Fontaine Modification Field Service Bulletin

Document #
FNT-103014025

Field Service Bulletin Name:
Peterbilt 220 Air Line Relocation

This document proposes the evaluation criteria and subsequent repair requirements related to possible interference between the VPD suction oil line and the chassis air compressor discharge line on Peterbilt 220 chassis used on Elgin Crosswind1 and Whirlwind1 sweepers. Inspection of the units will determine which condition(s) exist and what repairs are required.

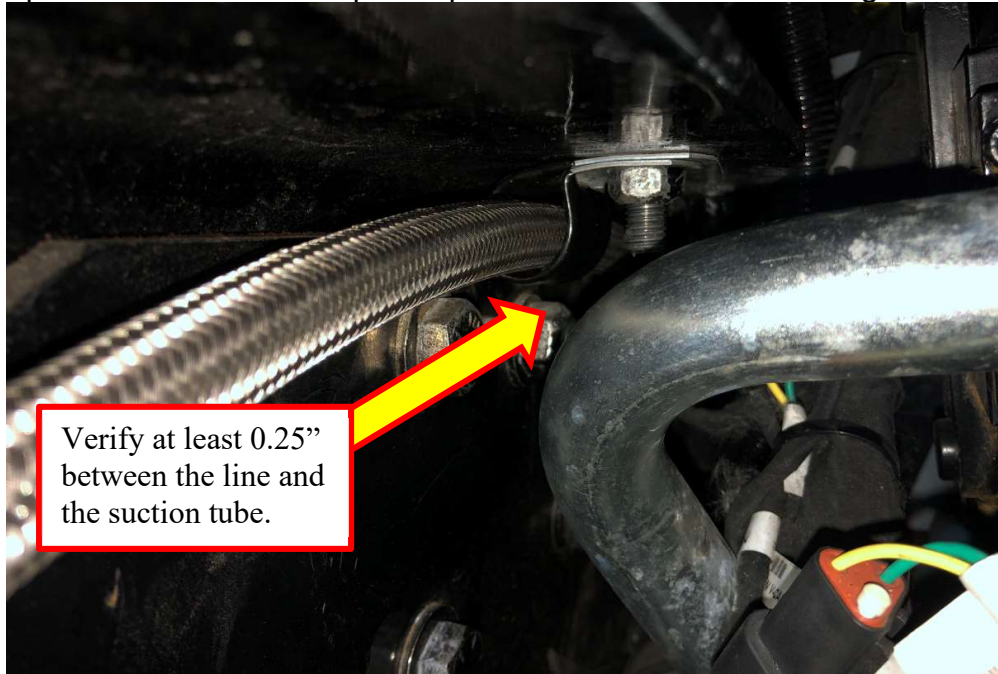
5.2.3 Remove the plate and cables where the support bar was connected.

5.2.4 Remove the bolt securing the p-clamp and discard the "L" bracket.

5.2.5 Swap the orientation of the p-clamp and bolt it to the frame using the existing hole.

5.2.6 Reassemble the ground cable plate, and VPD covers. **Verify there is at least 0.25" between the suction tube and the braided airline.**
